**STAFF RECOMMENDATION**

**2404 Belmont Boulevard**

**September 16, 2020**

**Application:** New Construction—Addition and Outbuilding; Partial Demolition

Figure 3. Proposed rear elevation.

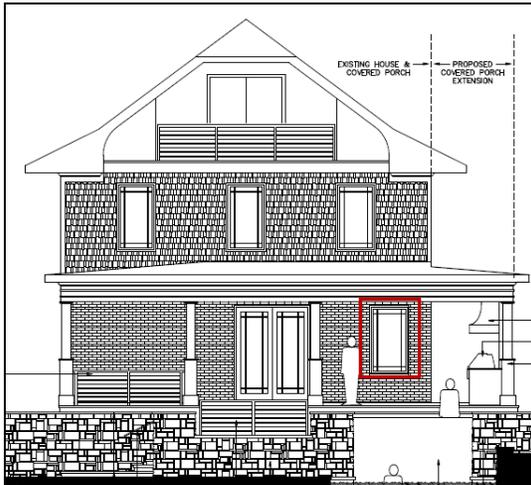
The plan also includes replacing the existing rear door and transom on the rear elevation with a single window and relocating the door and transom to the left-side elevation of the 2007 addition (Figure 3 and 4). Staff finds the changes to the openings to be appropriate given their location at or near the rear of an existing addition. No other changes are proposed with this application.

Figure 4. Proposed left-side elevation.

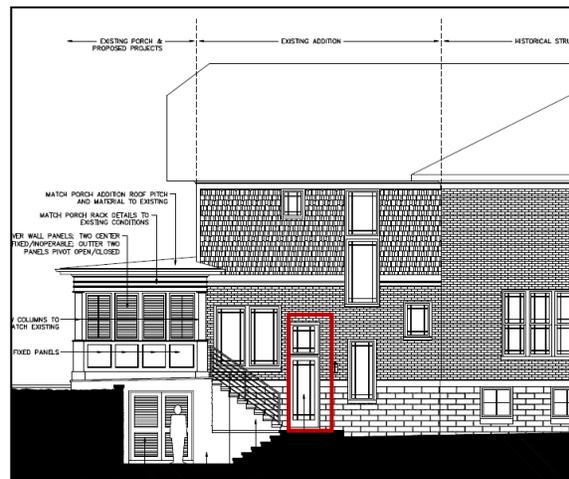
**Height & Scale:** The application proposes to expand the footprint of the covered porch by approximately ninety-one square feet (91 sq. ft.). The depth is to remain the same, but the porch will extend seven feet (7') wider on the left-side (Figure 3). The 2007 rear addition sets in two feet (2') from the rear corner of the historic house, so the proposed addition will extend five feet (5') wider than the historic house. The design guidelines states that “rear additions that are wider than an existing historic building may be appropriate when the building is narrower than 30' or shifted to one side of the lot.” In
